TMC SPECIFICATION NO. S -748

INSTALLATION SPECIFICATIONS FOR TIME DELAY
AND CONTROL RELAY MODIFICATION KIT # KIT-157

The purpose of modification kit KIT-157 is to increase the reliability of the time delay and control relay circuits within the PSP-350 power supply. This increased reliability can be obtained by providing a regulated coil voltage for control relay K-104. KIT-157 contains all the parts necessary to convert present PSP-350 units.

TITLE: INSTALLATION DIAGRAMS

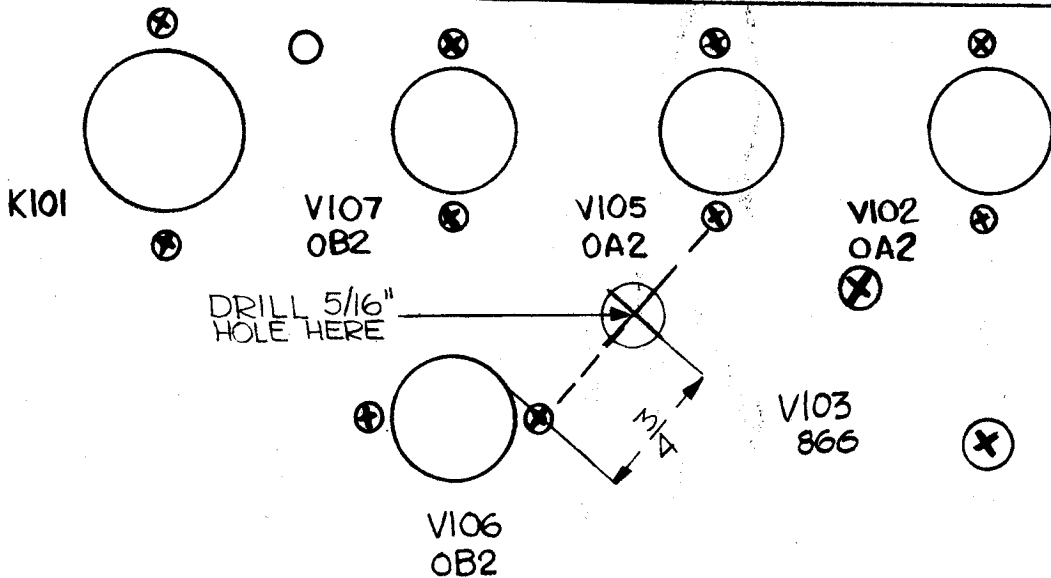
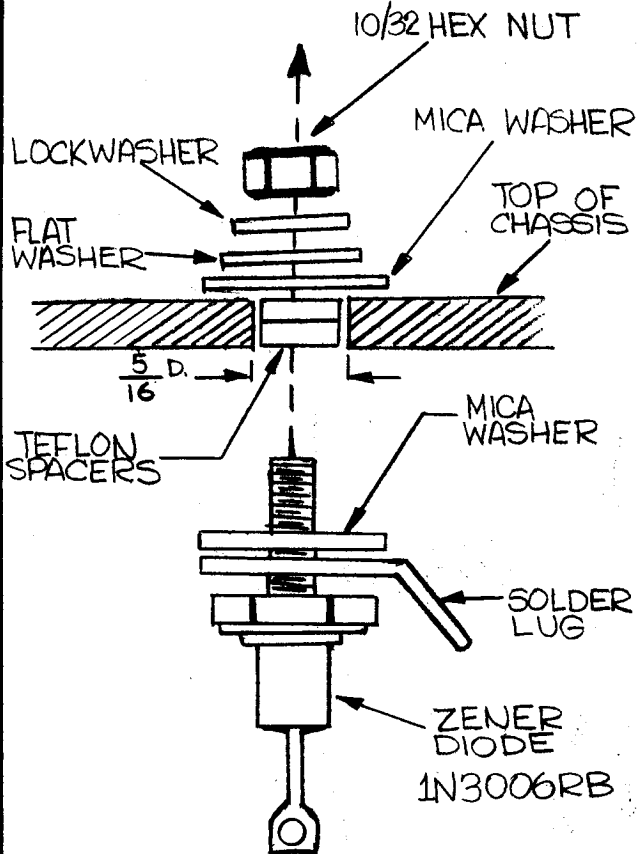
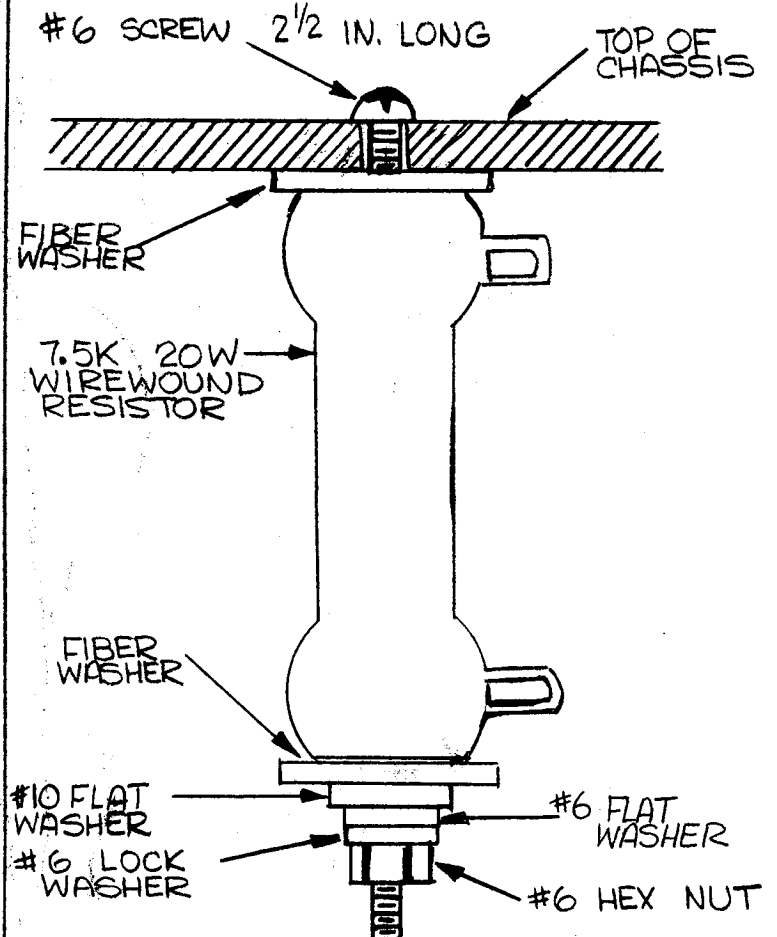
7. Cut the yellow sleeved negative lead of C-110 off pin 7 of V-102 socket.
8. Using the diagram on sheet 5 as a guide, drill a 5/16 diameter hole as shown using the drill bit supplied with the modification kit. Be sure to remove all burrs from around the hole and all metal shavings and dust from both of the chassis sides.

9. Install the Zener Diode as shown on sheet 5 with the cathode (case) lug pointing at pin 5 on V-107 socket. An ohmmeter check should be made to insure both cathode (case) and anode are isolated from the chassis. Both the anode and cathode should measure ∞ to the chassis.

10. Install the 7.5K 20 watt resistor supplied with the kit using the long screw, fiber washers, flat washer (all supplied with kit) and the flat washer, lock washer and nut retained in step 4. Point the terminals of the resistor toward terminal 4 on E-101. Note installation on sheet 5.
